# CIMARRON CORPORATION

Re: Docket No. 070-00925; License No. SNM-928  
Annual Submittal of 27(e) Changes

**ANNUAL SUBMITTAL OF  
27(e) CHANGES FOR (2004)**

**DOCKET NO. 070-00925  
LICENSE NO. SNM-928**

Figure 3-1

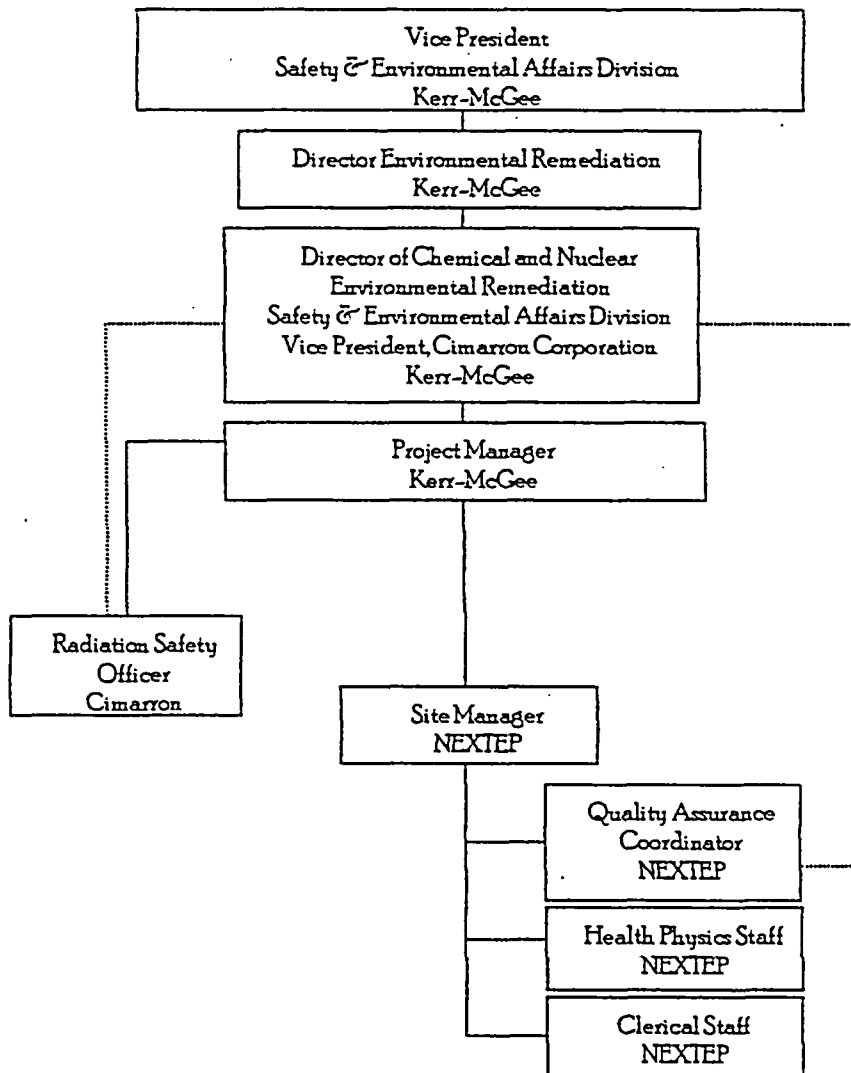
Revision to Organizational Chart – Removal of Program Manager – Sections 2, 3, Table of Contents and Review and Approval Signature Page

The current organizational structure for Cimarron Corporation is presented in Figure 3-1. Radiation Protection staffing levels shall be maintained in consistency with current and planned activities.

The Project manager is responsible to provide sufficient resources to implement the Radiation Safety Program and to perform site activities. The Project Manager oversees site staff, monitors regulatory requirements, site activities, scheduling and budget status.

Deleted: The Manager of Planning and Regulatory Compliance functions as the Project Manager for the site. The Project Manager is responsible to provide sufficient resources to implement the Radiation Safety Program and to perform site activities. The Project Manager oversees site staff, monitors regulatory requirements, site activities, scheduling and budget status. ¶

**TABLE 15-1  
CIMARRON FACILITY ENVIRONMENTAL SAMPLING SCHEDULE**

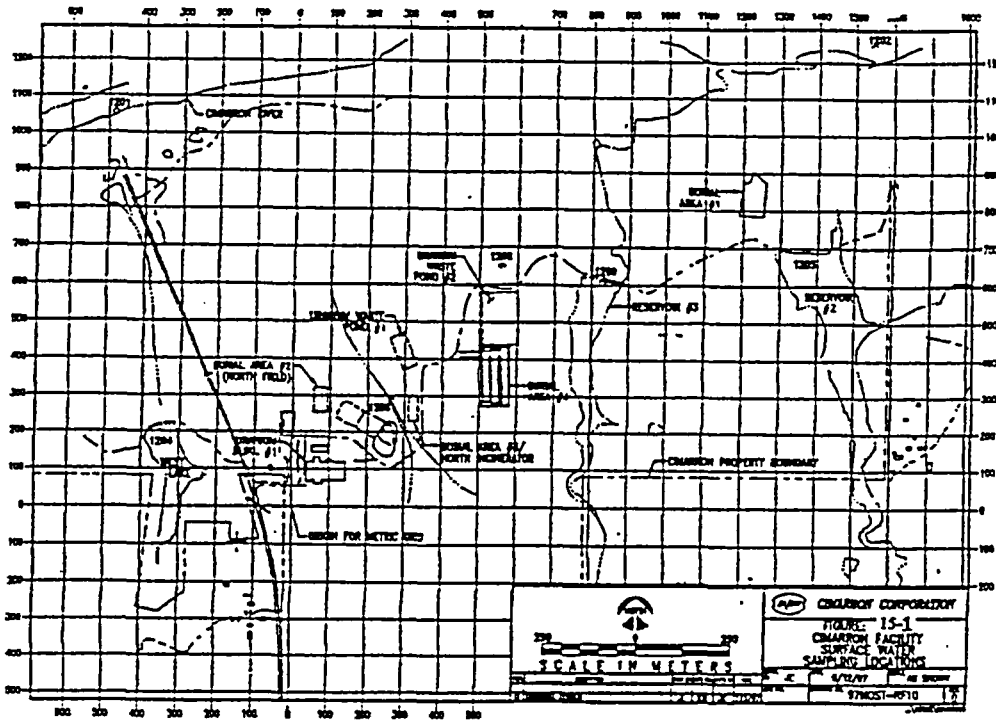
Removal of well 1319 from the Environmental Monitoring Program and replace with new wells 1319B-1 and 1319C-1.

**Deleted:** 1319 - Monitor Well - U-Plant Yard East of Building

FIGURE 15-2  
Groundwater Well Locations

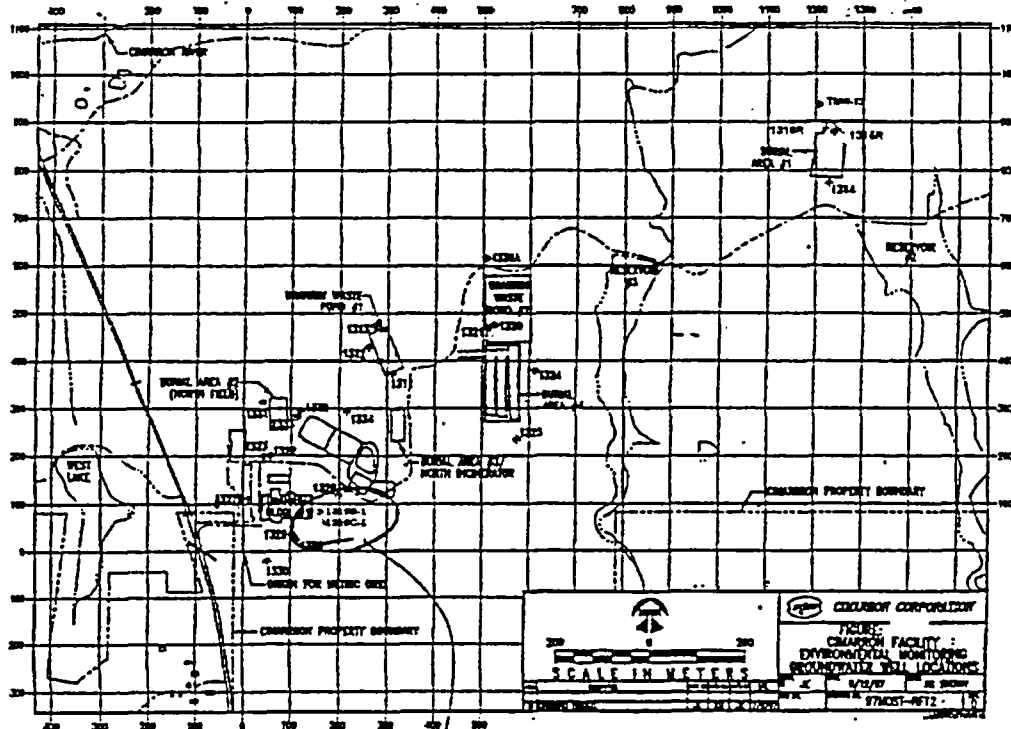
ADDED  
NEW  
WELLS
